Ici sont regroupées toutes les notes techniques émises par Moto Guzzi depuis 2004 jusqu'à aujourd'hui. Ou au moins toutes celles que j'ai pu obtenir.

Here is all Technical and Servicing Notes from Moto Guzzi, from 2004 since today. All of what I have picked up...

MODEL	ABOUT...	SERVICE NOTE	DATE	TECHNICAL NOTE	DATE
All models	Electrical diagnosis improvement	---	---	008-2008	30/09/08
All models	Neutral sensor	---	---	002-2010	19/07/10
All models	Cleaning throttle body	---	---	005-2010	29/10/10
All models	Compatibility with E10	---	---	004-2011	13/09/11
All models	Diagnosis instrument : PADS	---	---	005-2012	28/03/12
All models	Handling and Storage	---	---	003-2013	26/03/13
All models	Speedometer indication	---	---	007-2013	16/05/13
All models	Control of the position of the electrical wiring harness	---	---	014-2013	31/07/13
All models	Battery initialisation	---	---	007-2014	17/07/14
All models	Vehicle servicing time	010-2012	09/2012	---	---
All models	Vehicle servicing time	002-2013	03/2013	---	---
All models	Vehicle servicing time <i>Only french version available for the moment</i>	xxx-2013	12/2013	---	---
All models	Warranty : modified components	004-2013	003-9967	---	---

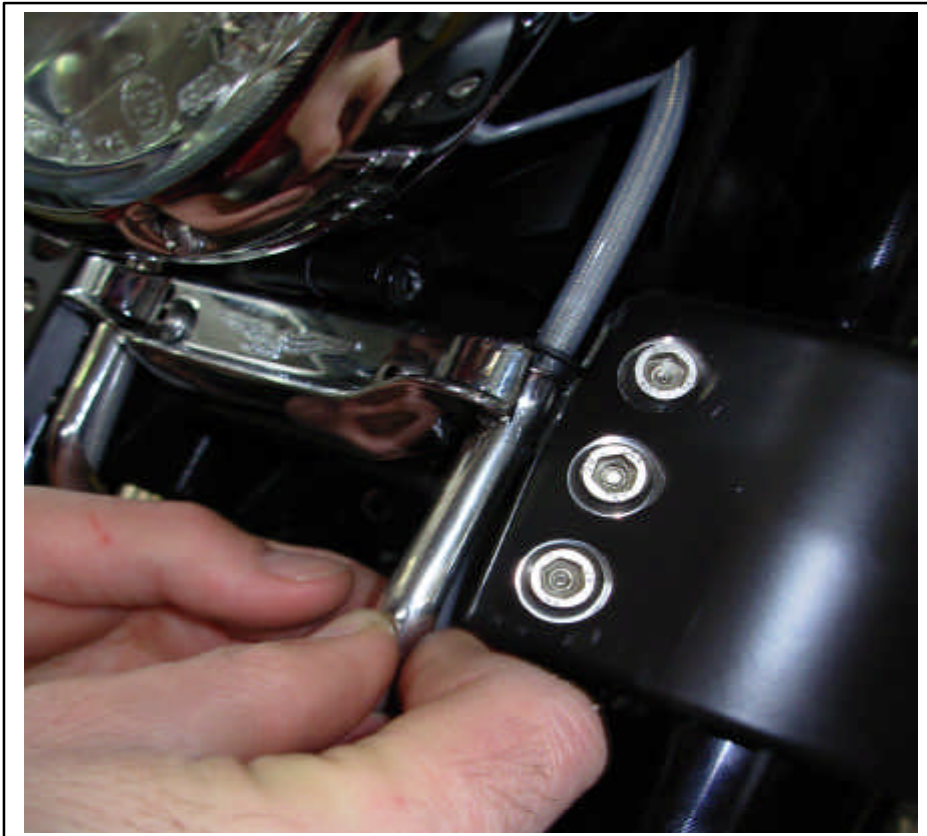
- 1) Loosen the two M5 retaining screws from brake line plate

- 2) Insert the two front brake line supports (part no. 977552 to be checked) into line plate

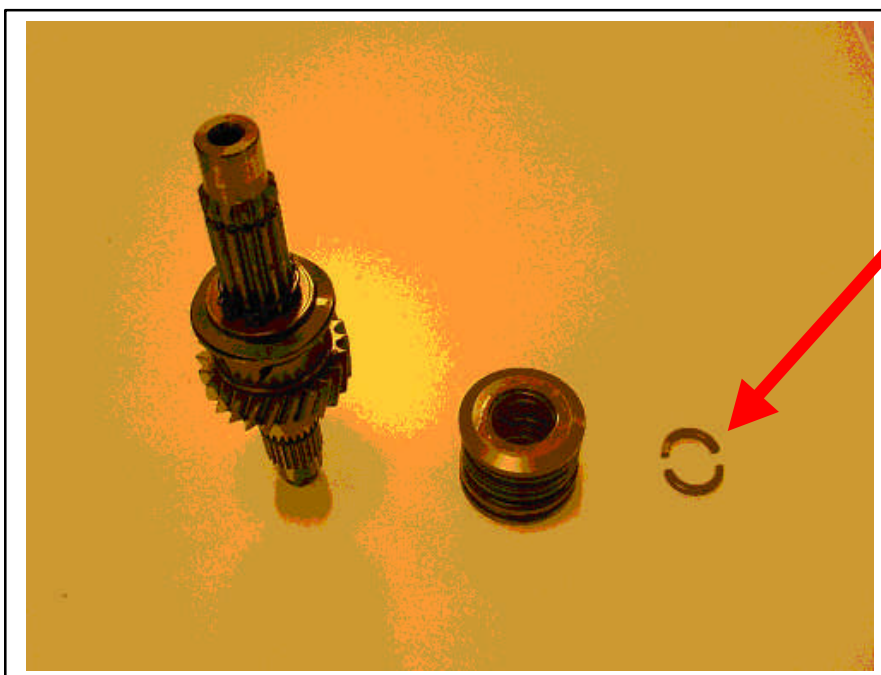
- Compress the Belleville washers until retainer (part 15) is released

- Remove the Belleville washers (part 13)
- Remove the cap (part 12)
- Insert the two shaped washers
- Refit the cap (part 12)
- Refit the Belleville washers (part 13)
- Refit the shaft
- Compress the Belleville washers
- Refit the retainer (part 15)
- Reassemble gearbox assembly
- Refit gearbox assembly to the engine.

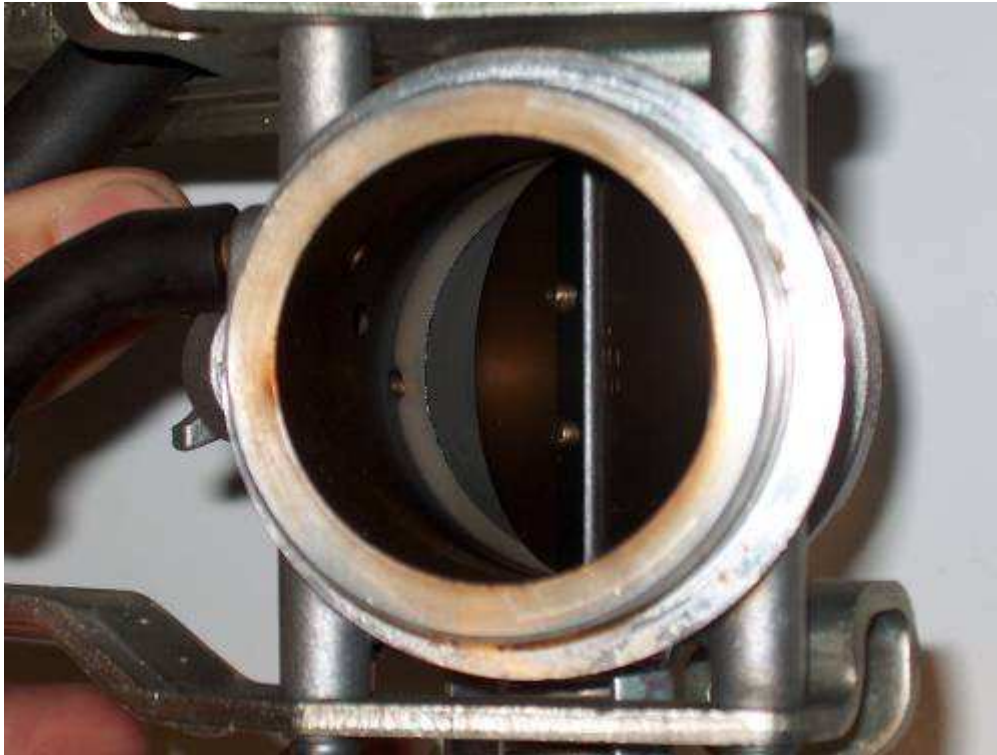
The following image shows significant deposits of unburnt fuel residue in the air duct: with the throttle closed, these deposits impede the injection system from delivering the correct air fuel mixture, compromising engine function at idle or at throttle lift-off and causing engine cut-out or irregular idling.

The throttle body must be cleaned with specific products for cleaning throttle bodies or carburetors.

Proceed as follows: with the throttle valve fully open, clean the duct with a normal cloth - do not use brushes or rotary brush attachments; never remove the throttle valves from the body.

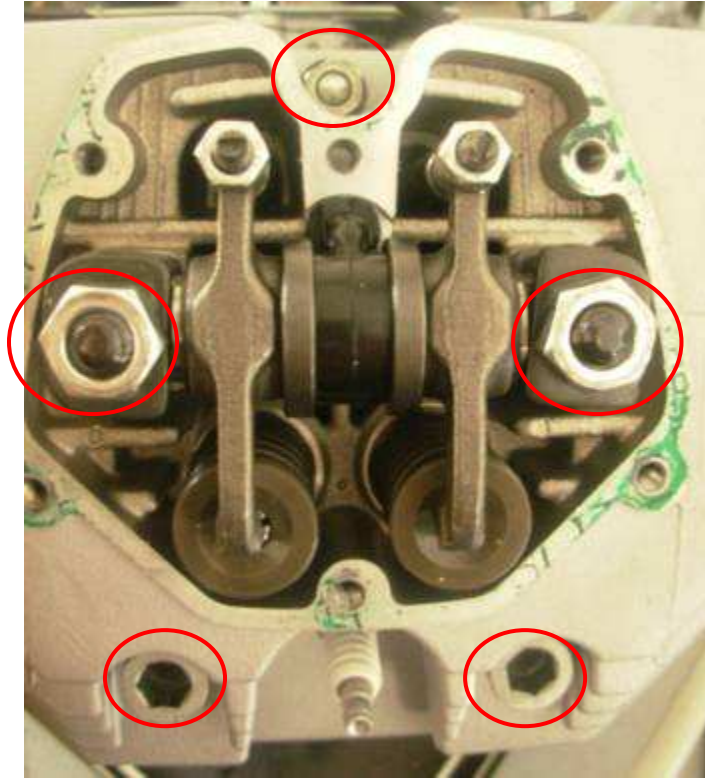
Dear Dealer,
we would like to remind you of the importance of checking that the cylinder head studs are tightened correctly at the first (1000 Km) service, is indeed indicated in the maintenance schedule.
Please note that the correct tightening torques are as follows (see exploded drawing):

stud bolt (1) - M8 nut (6) = 28 Nm
stud bolts (2) and (3) - M10 nut (4) = 42 Nm
Long nut (5) = 25 Nm

The nuts which must be checked are indicated in the figure.

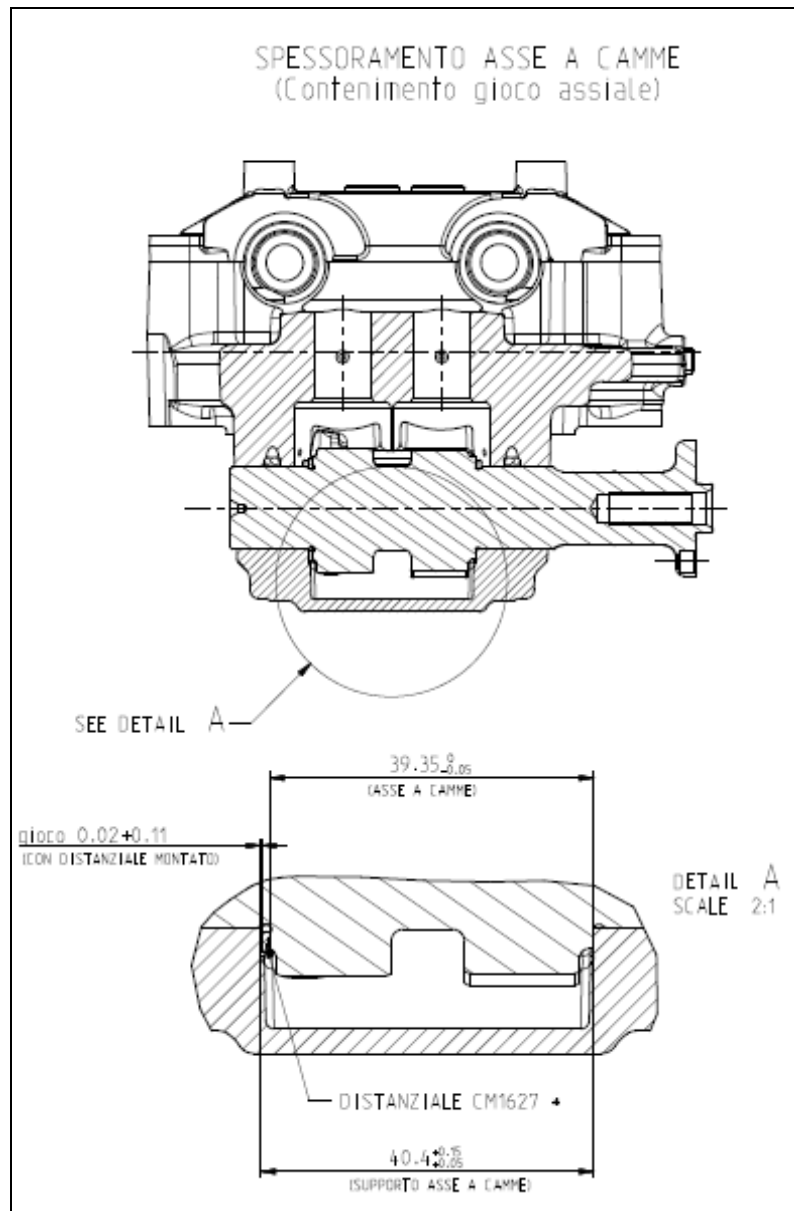
Before fitting the camshaft, you are kindly requested to check the dimension indicated in the following photo:

If the dimension measured is 40.35 mm, the camshaft may be installed with no additional shim.

If the dimension measured is 39.35 mm, a shim of the appropriate thickness must be added.

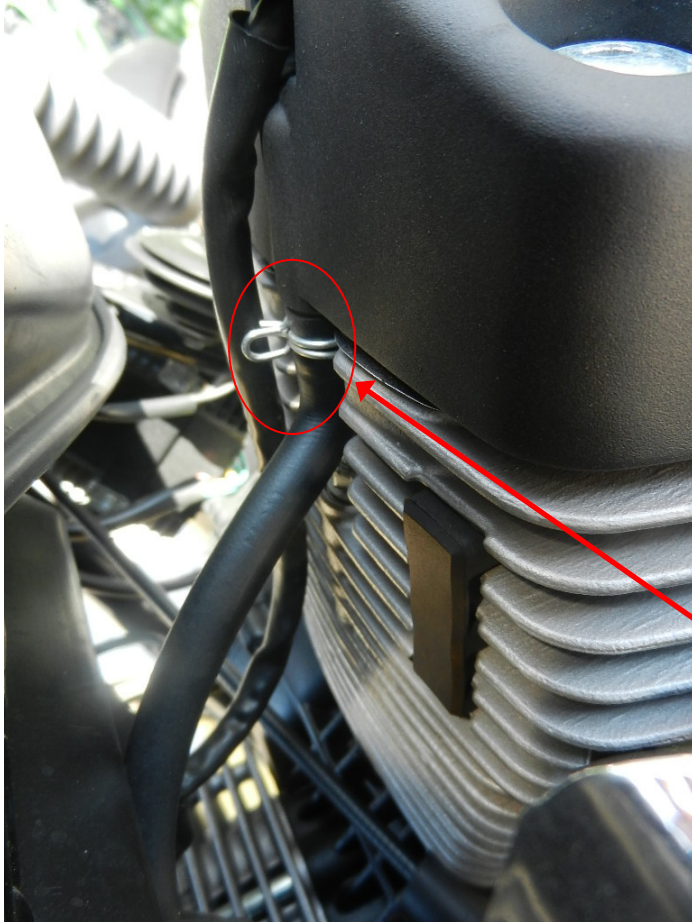
Remove COD.
AP8102239

Insert COD. AP8201358

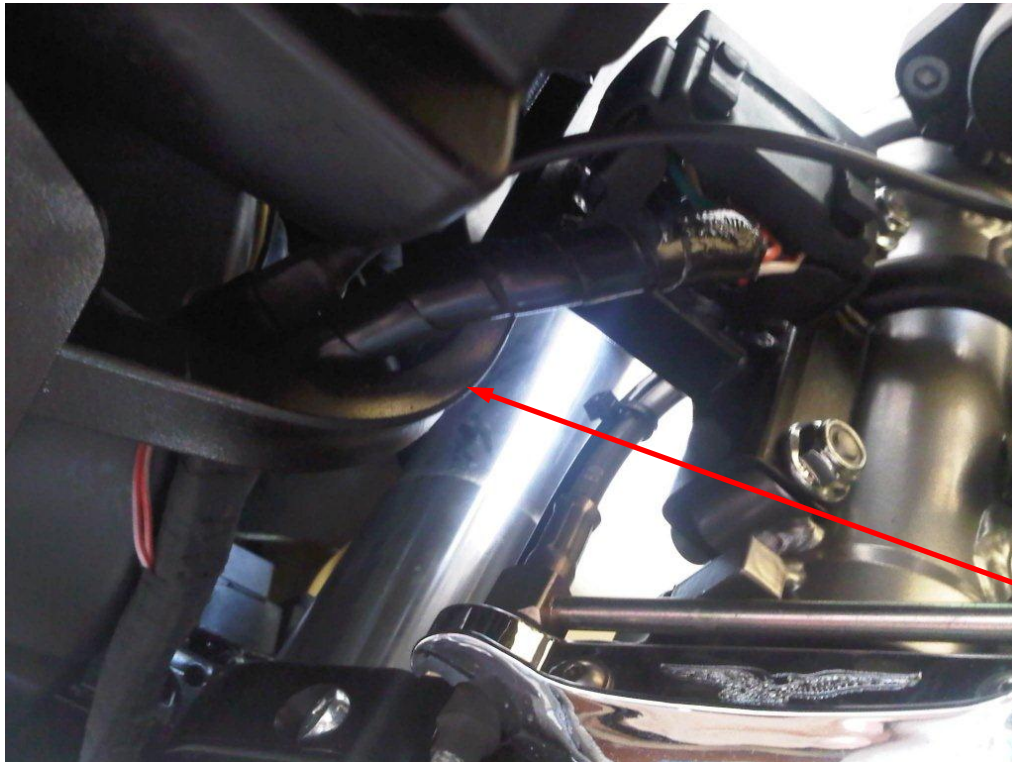
- Cut a section of 150mm of the spiralled protection and roll it around the cable harness starting from the bifurcation area of the cable harness as shown in the picture, taking care to keep the spirals wound tightly to each other; fix the ends of the protection with adhesive tape

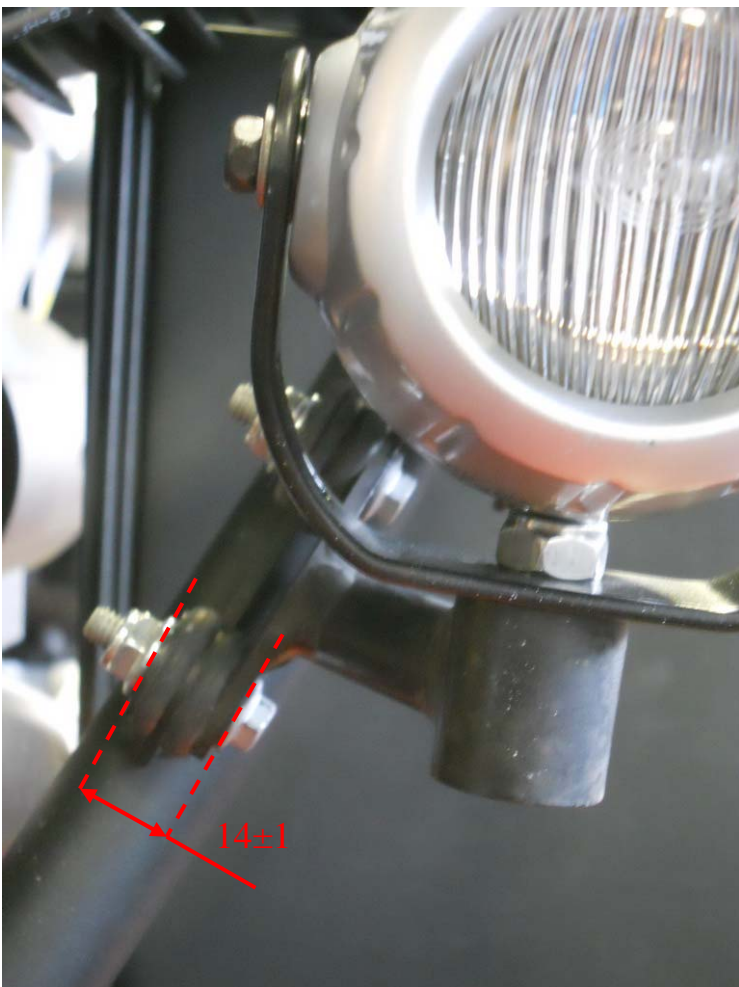
- Insert the rubbers between the bracket and support and then insert the washer between the nut and rubber as shown in the picture

- Tighten the nut until obtaining a distance between the outside of the washer and the outside of the spotlight support of $14\pm 1\text{mm}$

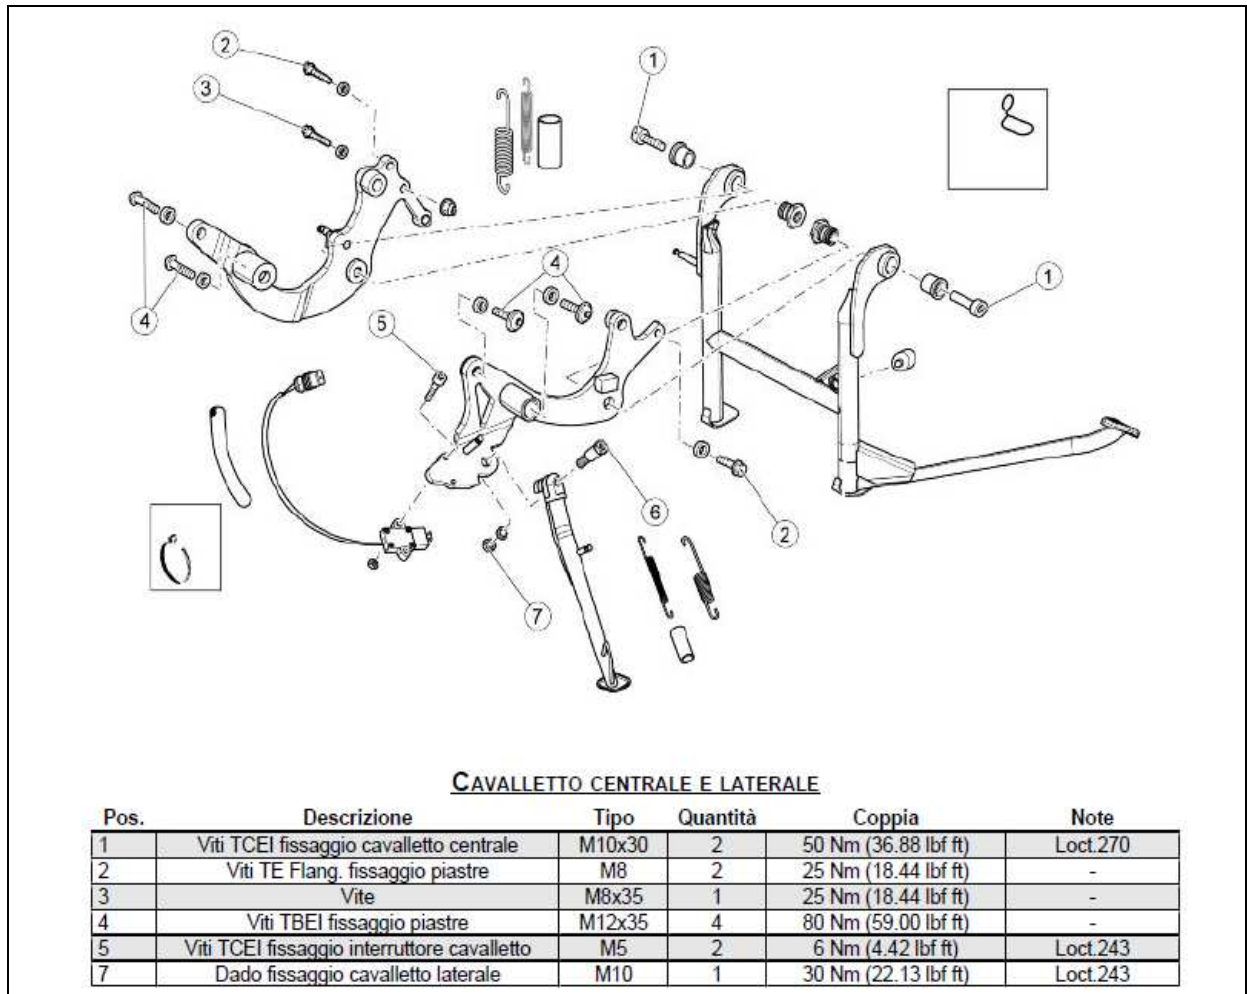
- Remove the return springs of the stand and the stand itself by removing the relative fixing screws

- Fit the new **central stand cod.887544** remembering to hook the return springs
- Reposition the motorcycle on the central stand by slowly lowering the bench lift

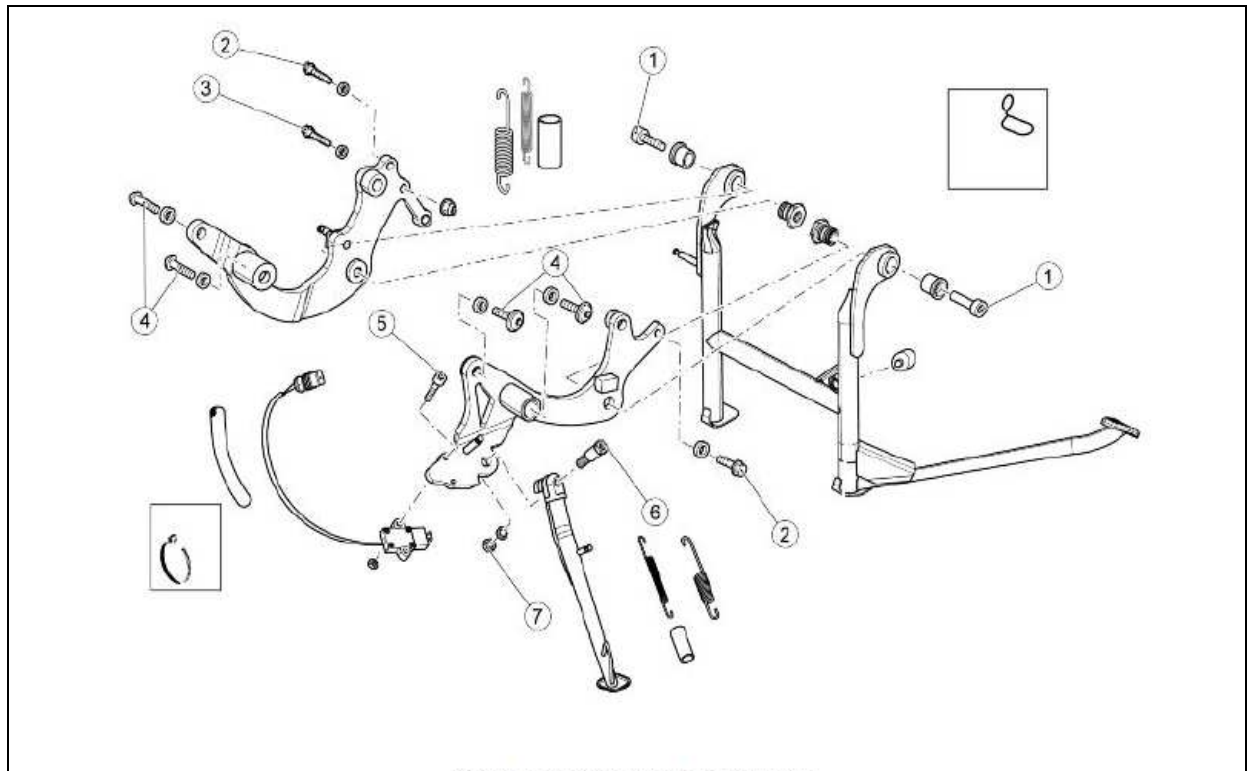
- Rotate the right side exhaust manifold, detaching it from the right cylinder and loosen the lower mounting to allow the most suitable position; also loosen the right side rider footrest mounting through the removal of the relative screws; at this point there is full access to the removal of the fixing screws of the right stand side support plate which is replaced with the **right plate cod. 883664**

- Refit the rider footrest mounting, reposition the manifold
- Fit the new **central stand cod.887544** remembering to hook the return springs
- Reposition the motorcycle on the central stand by slowly lowering the bench lift

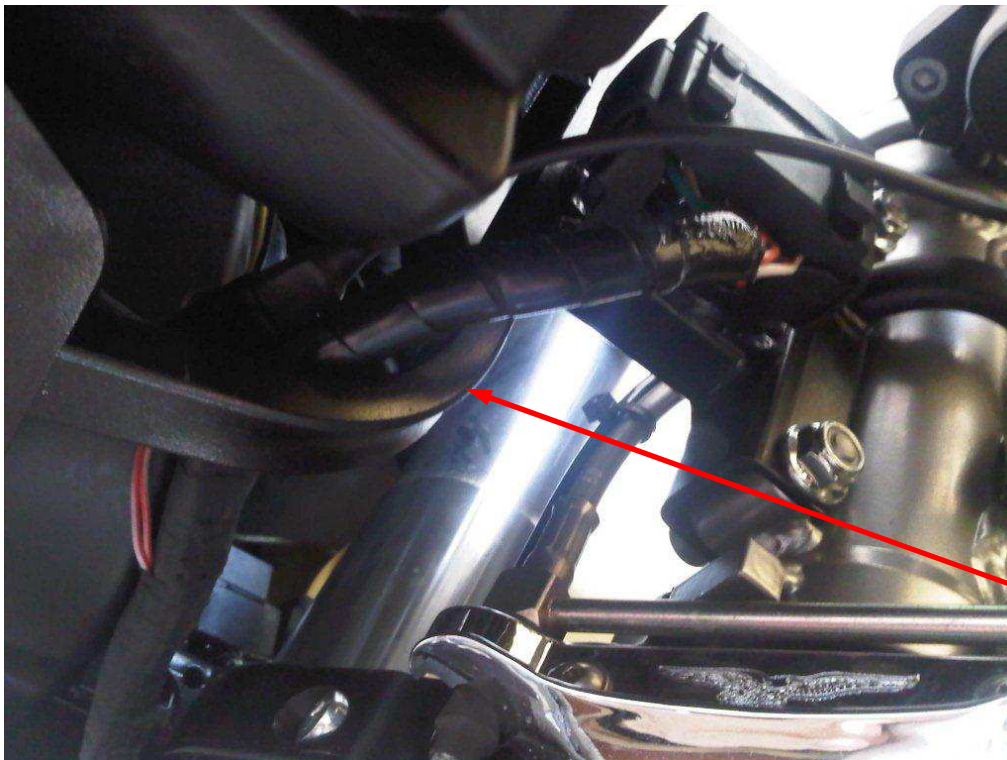
- Cut a section 150 mm of the **spiralled protection cod. AP887947** and roll it around the cable harness starting from the bifurcation area of the cable harness as shown in the picture, taking care to keep the spirals wound tightly to each other; fix the ends of the protection with adhesive tape
